REQUEST FOR WRITTEN APPROVAL TO USE CONSTRUCTION METHODS NOT INCLUDED IN OREGON ADMINISTRATIVE RULES 690-200 THROUGH 690-240

Merganser Well

(2) Start Card Number(s): 135715

- (7) Diagram showing the pertinent features of the proposed well design and construction (attach additional pages if needed):

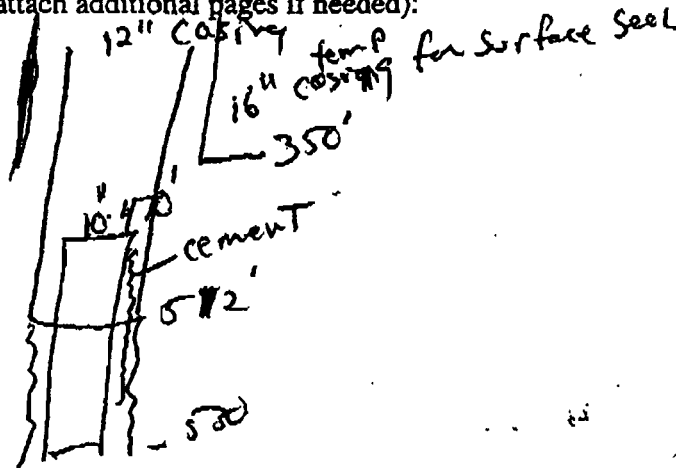
(5) The unusual conditions which necessitate this request: 12" casing driven
further than 500' to reach Basalt

(6) The proposed construction methods that the well constructor believes will be adequate for this well (attach additional pages if needed): Drill 12" hole
Basalt from 512 to 530 cement 60' of 10" casing
470-530

Approved ☒
